**SUPPLEMENT NO. 2
HOLLAND HILL SCHOOL PHASE 1
ADDITIONS AND ALTERATIONS
GILBANE JOB NO. J07285.000
STATE PROJECT NO. 051-0146 EA
February 23, 2018**

The following items are hereby made part of the bid documents for Holland Hill School Phase 1 – Additions and Alterations Construction Documents:

- Addendum #1 for Holland Hill Elementary School as prepared by Kenneth Boroson Architects, dated February 23, 2018, attached.
- Holland Hill School Additions and Alterations Bid RFI Log dated February 23, 2018, attached.
- Delete Gilbane Project Manual section 00 31 13 – Project Schedule dated September 1, 2017 with Data Date 1/4/18 and replace with section 00 31 13 – Project Schedule dated February 23, 2018 with Data Date 2/22/18, attached.

FOUNDATION PLAN - PART A

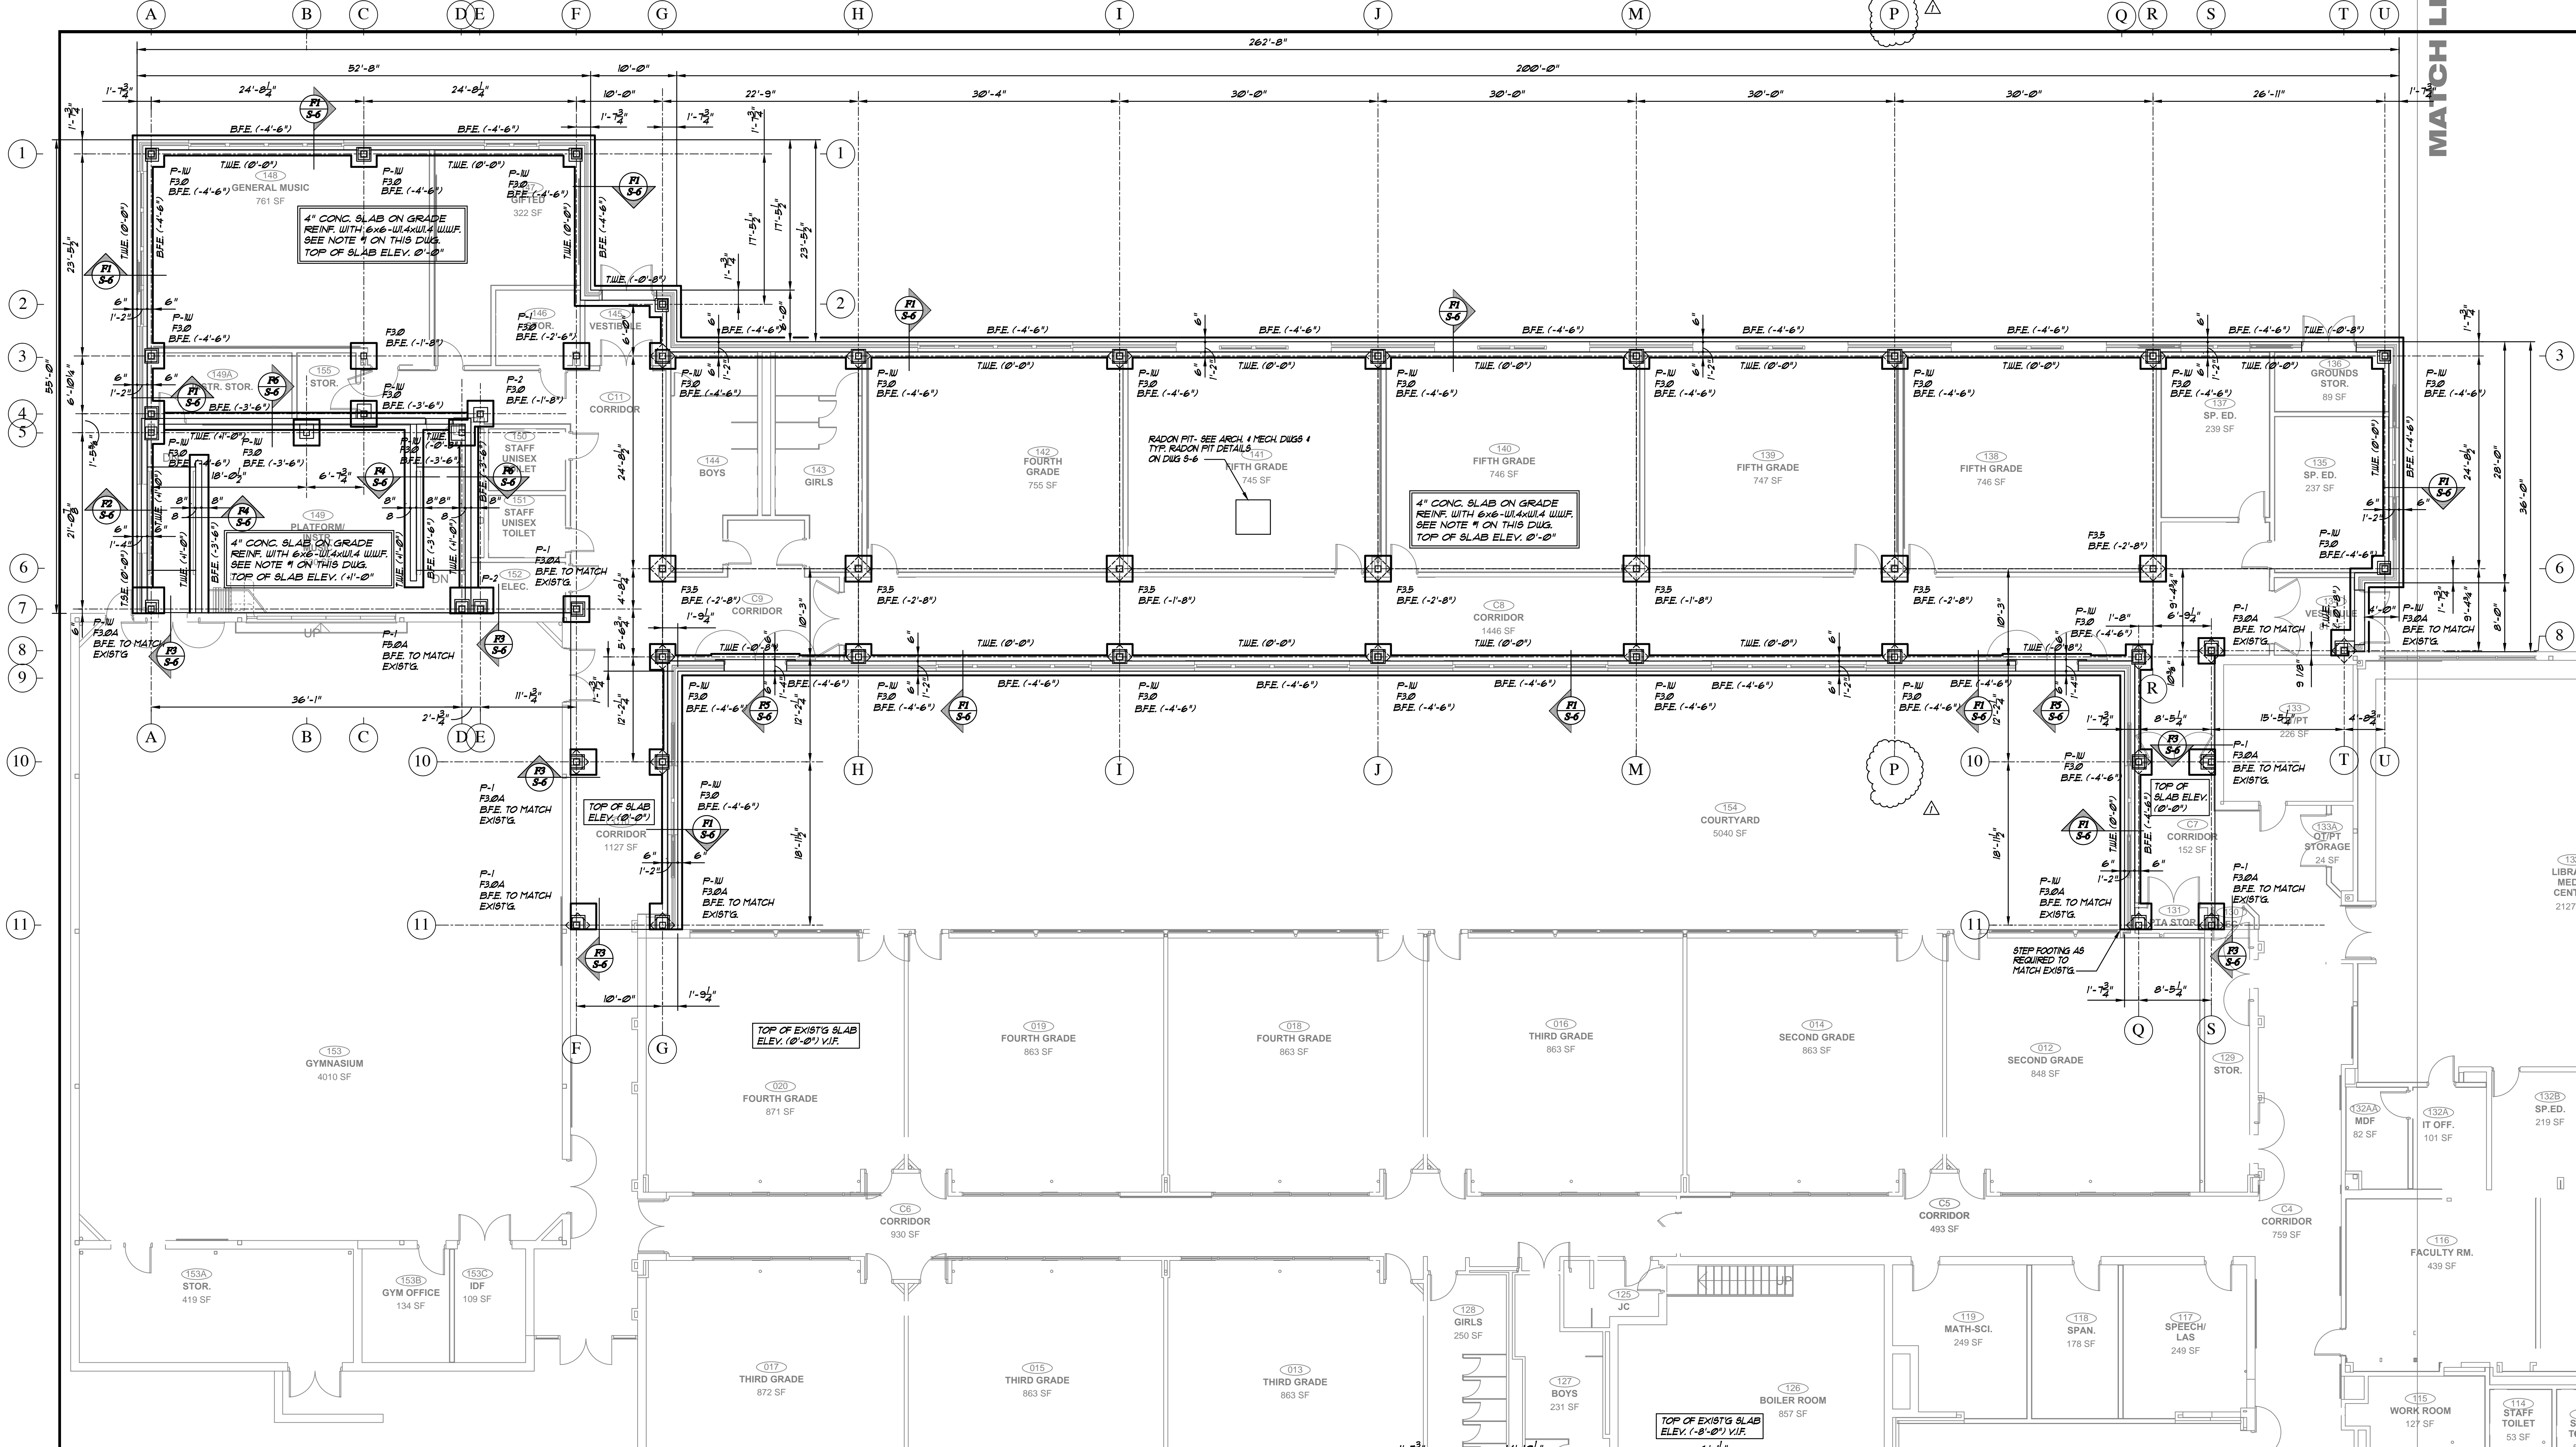
REVISE drawings S-1, S-2, and S-4, see attachment

142	2/22/2018	31A	Sitework	Please confirm that BP 03A Concrete is responsible for the furnish and install of the vapor barrier as noted in BP 03A Concrete Specific scope items # 1 and #9 and that it is not part of BP 31A Sitework as answered in RFI #4	Gilbane	2/23/2018	Correct. BP 03A will provide the underslab vapor barrier specified per 03 33 00.	2
143	2/22/2018	31A	Sitework	Please clarify the limits of rigid insulation to be furnished and installed by BP 31A Sitework. Plan sheet S-03 has a detail for typical interior slabs that does not show rigid insulation under the slabs but plan sheets A6.10 thru A6.17 notes that rigid insulation is to be installed under floor slabs.	Gilbane	2/23/2018	Provide under slab insulation per the architectural details.	2
144	2/22/2018	31A	Sitework	Please clarify the makeup of the typical slab on grade. Plan sheet S-03 shows 4" of 3/8" crushed stone on granular fill but on plan sheet part A note #1 and the geotechnical report section 4.5.1 has concrete slabs placed on 12" of structural fill and no mention of 3/8" crushed stone.	Gilbane	2/23/2018	Provide per S-1 Foundation Plan Part A note #1	2
